**ISSUES OF NON-COMPLIANCE WITH THE DEPARTMENT OF TREASURY'S
GUIDANCE TO MDBS FOR ENGAGING WITH DEVELOPING COUNTRIES ON COAL-
FIRED POWER GENERATION**

**SIERRA
CLUB**
FOUNDED 1892

Introduction

New Coal Will Dramatically Raise Electricity Rates

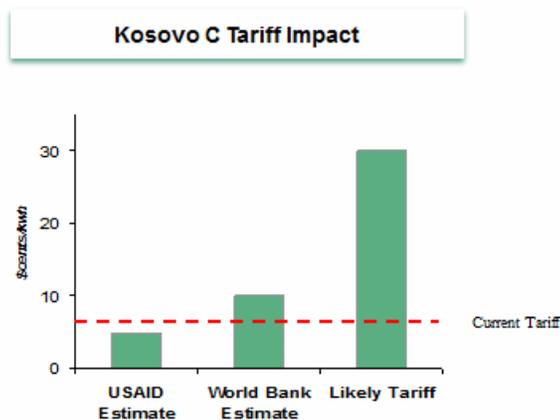
Both the Kammen and INDEP/Sierra Club studies identified alternative portfolios that could provide the needed energy services at substantially lower cost than the proposed project. The Kammen study found that its alternative low-carbon portfolio would cost 50 percent less than the proposed project (and would have greater job creation benefits and much lower environmental and social externalities).²⁵

Similarly, the INDEP/Sierra Club analysis found that the World Bank's *Background Paper* significantly underestimated the tariff increases that will be necessary to finance the simultaneous renovation of the Kosovo B plant, construction of the proposed new 600 MW plant, and the development of a new mine. This is so for two reasons. First, the Kosovo C plant will be encumbered with far higher debt costs than the currently operating units, even after Kosovo B is refurbished. The Bank's analysis does not calculate the short-term tariff increases that will be required to cover the increased fixed and operating cost of a \$1 billion dollar investment – only the Levelized Electricity Cost (LEC). And the Bank's calculation understates the true LEC by assuming that the capital costs of the project can be repaid over the entire 40 year life of the project, even though both debt and equity investors will likely expect repayment over a much shorter time frame. Second, because the new plant and the renovated Kosovo B will produce significant excess base load capacity, Kosovo B, Kosovo C, or both will have to be run at uneconomic capacity factors, substantially reducing the amount of time they will be online and generating revenue.²⁶ As a result, tariffs up to four times higher than current rates may be needed to service the total new investments.²⁷
